15.7 Radioactive Release from Subsystems and Components

The information in this section of the reference ABWR DCD, including all subsections, figures and tables, is incorporated by reference with the following departure and supplements.

STD DEP 11.3-1 (Figure 15.7-2)

Figure 15.7-2 Offgas System (See Subsection 11.3)

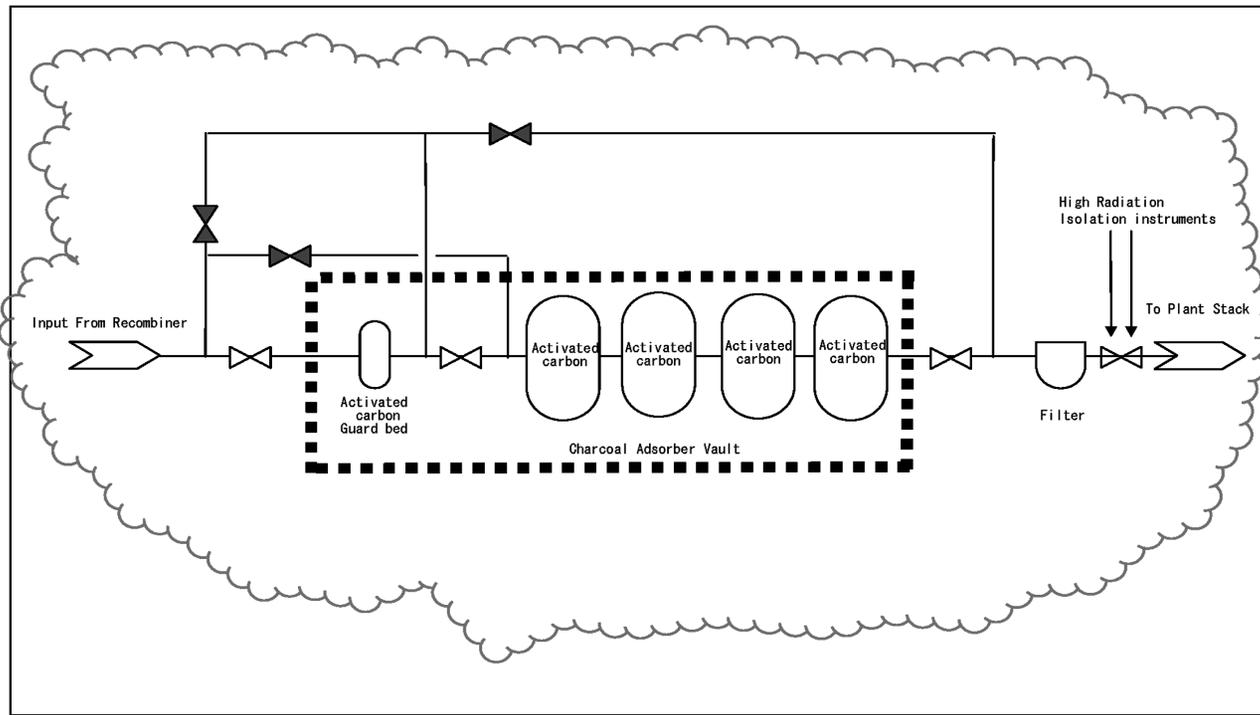
To evaluate the potential radiological consequences of an inadvertent bypass of the charcoal beds, it was assumed that operator error or computer error has led to the bypass of the ~~eight~~four follow-on beds in addition to the failure of the automated air operated downstream isolation valve. It is also assumed that during this period, the plant is running at and continues to run at the maximum permissible offgas rate of 14.8 GBq/s (based upon the assumption of 0.0037 GBq/s/MWt as stipulated in Standard Review Plan 11.3) evaluated to a decay time of 30 minutes from the vessel exit nozzle. Even with the failure of the downstream isolation valve, it is not anticipated or assumed that the isolation instrumentation would fail but would instead

- (1) Flow is through a single 4,721 kg charcoal tank with an evaluated hold up time given by NUREG-0016, equation 1.5.1.6 using K_d 's for Kr and Xe from NUREG-0016.
- (2) ~~An isolation valve prevents flow through the~~ ~~There is no motive force to remove any significant inventory from the eight~~ follow-on charcoal tanks while in bypass and therefore no activity from these tanks is included in the final release calculations.
